**SAFETY
RECALL**

SR13-05A

DATE : FEBRUARY 2013	SECTION : 18-BODY
SUBJECT : NEW SIDE MARKERS WITH NON-REFLECTIVE LENS - ADDITION OF AMBER REFLECTORS

REVISION : A THIS SAFETY RECALL SUPERSEDES PREVIOUS VERSION.
Vehicles added to the Application table

CURBSIDE DOOR

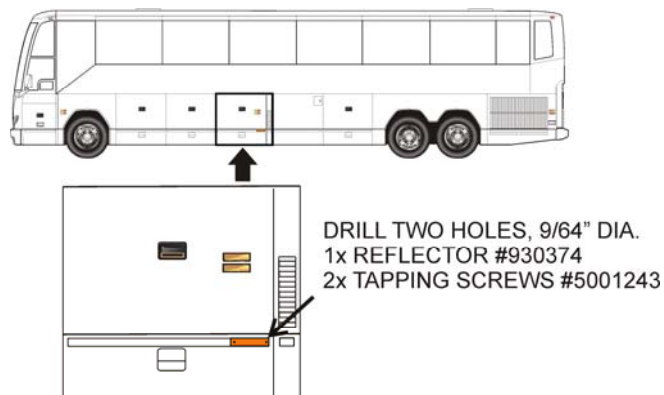
1. Position reflector #930374 on the reflective band and mark holes position using the reflector holes as reference.
2. Drill two (2) 9/64" diameter holes. Drill through the reflective band and the baggage compartment outside panel but not deeper.
3. Secure the reflector using two (2) tapping screws #5001243.

EVAPORATOR DOOR

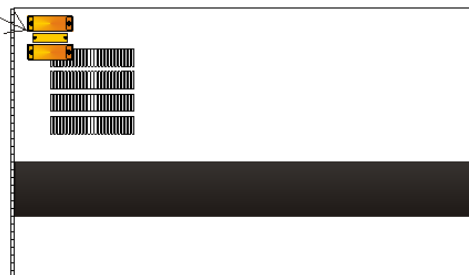
1. Position reflector #930212 centered both vertically and horizontally between the existing side marker lights and mark holes position using the reflector holes as reference.
2. Drill two (2) 9/64" diameter holes. Drill through the outer stainless steel panel but not deeper.
3. Secure the reflector using two (2) tapping screws #500124.

DRILL TWO HOLES, 9/64" DIA.
1x REFLECTOR #930212
2x TAPPING SCREWS #500124

CONDENSER DOOR

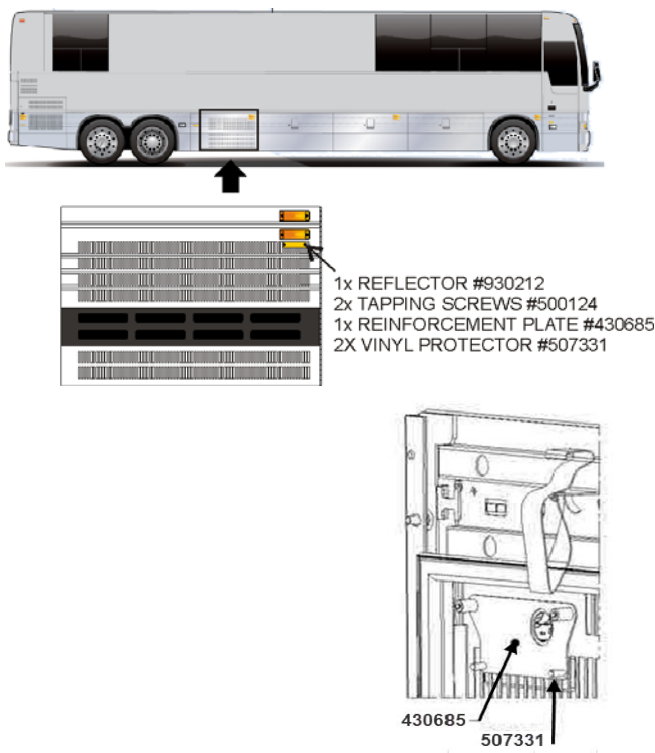
1. Open the condenser door. Unscrew the two (2) well nuts securing the existing lower side marker light.
2. Using the existing lower side marker light screws and well nuts, secure the top of the reinforcement plate #430685.
3. Using reinforcement plate #430685 and two (2) tapping screws #500124, secure reflector #930212.
4. To prevent injuries, add a vinyl protector #507331 on each screw.

EVAPORATOR DOOR

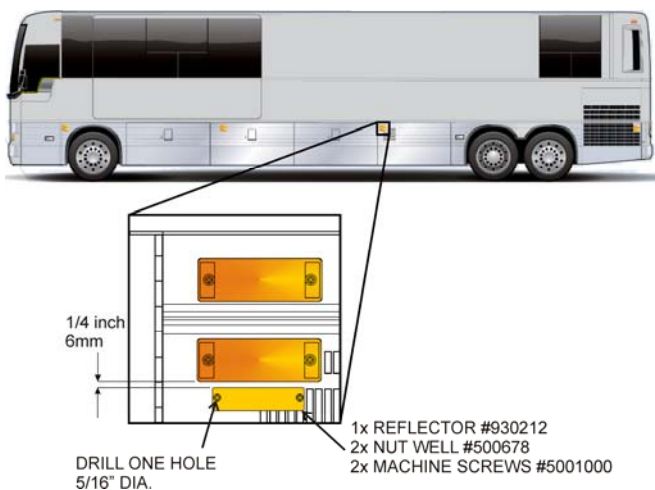
1. Position reflector #930212 1/4" (6mm) under the lower side marker light and centered horizontally with it as shown and mark one (1) hole position using the reflector left hole as reference.
2. Drill one (1) 5/16" diameter hole at left. Drill through the outer stainless steel panel but not deeper.
3. Secure the reflector using two (2) machine screws #5001000 and two (2) well nuts #500678.

XLII ENTERTAINER / X3-45 VIP SHELLS WITH SMALL HVAC SYSTEM

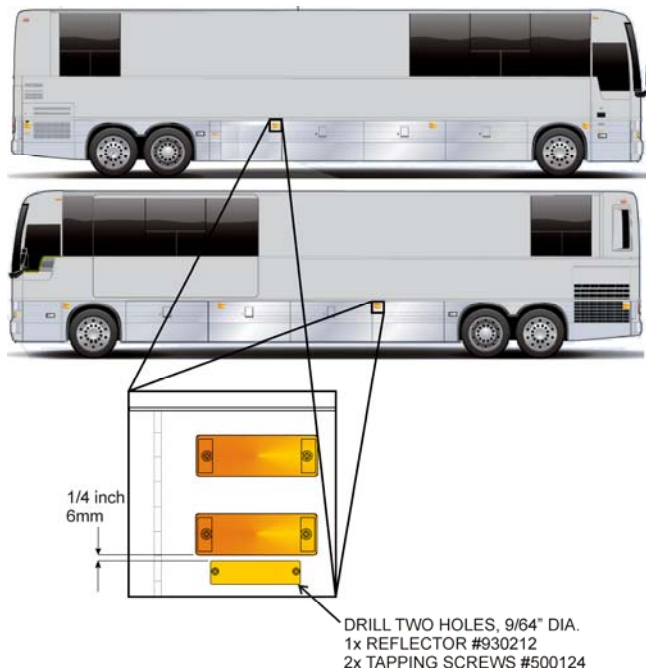
1. Position reflector #930212 1/4" (6mm) under the lower side marker light and centered horizontally with it as shown. Mark two (2) holes position using the reflector holes as reference.
2. Drill two (2) 9/64" diameter holes. Drill through the outer stainless steel panel, but not deeper.
3. Secure the reflector using two (2) tapping screws #500124.
